SERVICE BULLETIN

B-060

SAFETY RECALL CODE 0830 - SIDESTAND PIVOT BOLT FOR 2005 FIREBOLT XB12R AND LIGHTNING XB12S, XB9SX

Figure 1. Correct Pivot Bolt with Springplate Pin

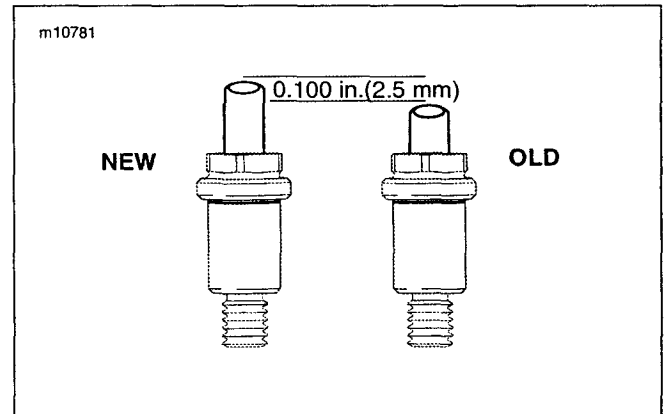
See Figure 1. Correcting the potential safety defect requires replacement of the sidestand pivot bolt, Part No. L0174.1AA. The replacement pivot bolt, Part No. L0174.1AAB, is 0.100 in. (2.5 mm) longer in the spring plate pin area and has a gold hue plating. **The recall kit Part No. is 94394Y.**

Figure 2. Sidestand Assembly

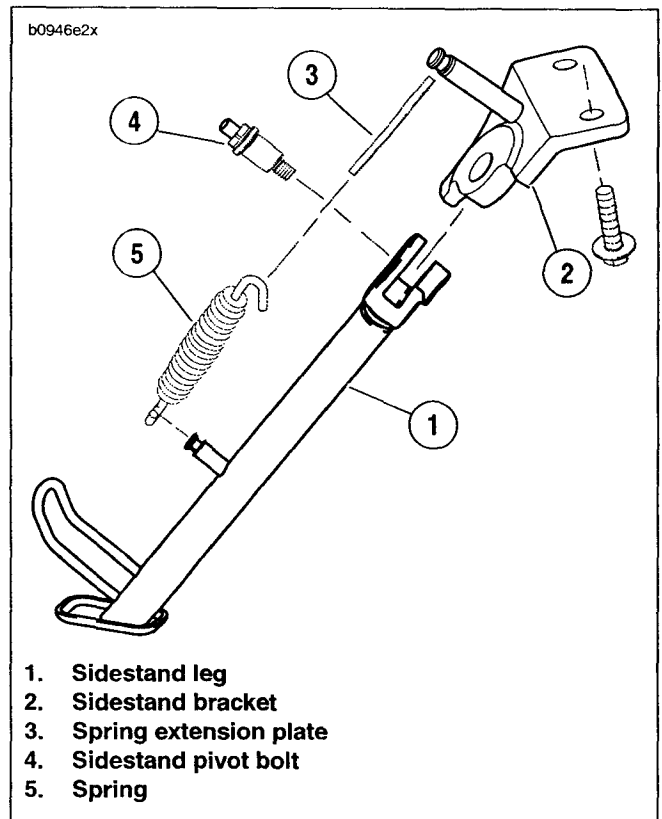
1. Remove two fasteners from left side of chin fairing.
2. See Figure 2. Remove sidestand pivot bolt (4).
 - a. Retract sidestand leg.
 - b. Remove sidestand spring (5) and spring extension plate (3) using SNAP-ON SPRING TOOL (Part No. HE-52B).
 - c. Remove sidestand pivot bolt (4).

- c. See Figure 2. Install sidestand pivot bolt (4) tightening to 18-20 ft-lbs (24-27 Nm).
- d. Retract sidestand leg.
- e. Install spring extension plate (3) and sidestand spring (5) using SNAP-ON SPRING TOOL (Part No. HE-52B).

Figure 3. Lubricating Points (Shaded Areas)

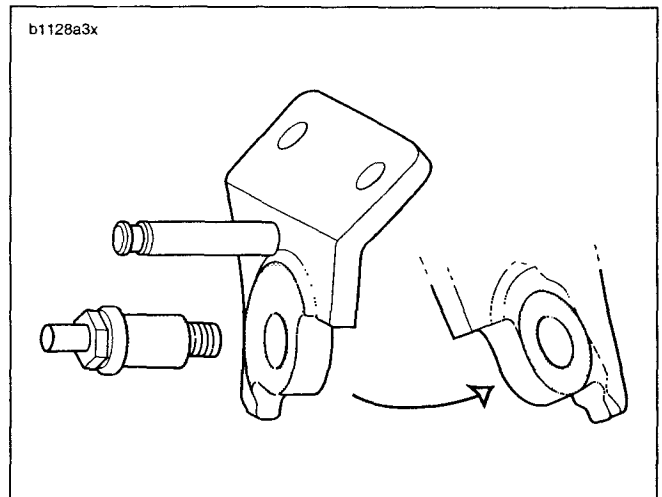
1. Install **new** longer sidestand pivot bolt (4).
 - a. See Figure 3. Lubricate sidestand pivot bolt and mating portions on sidestand bracket with WHEEL BEARING GREASE (Part No. 99855-89) on shaded areas only.
 - b. See Figure 4. Apply LOCTITE 272 (Red) to threaded area (clevis) of sidestand leg.

Figure 4. Threaded Area for Loctite Application

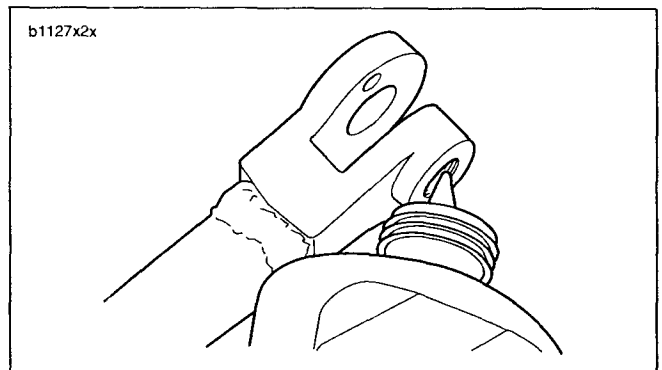
Applying LOCTITE to threaded area of clevis on sidestand leg, instead of threads on the pivot bolt, will eliminate build-up between clevis and sidestand bracket which can interfere with the applied lubricant.
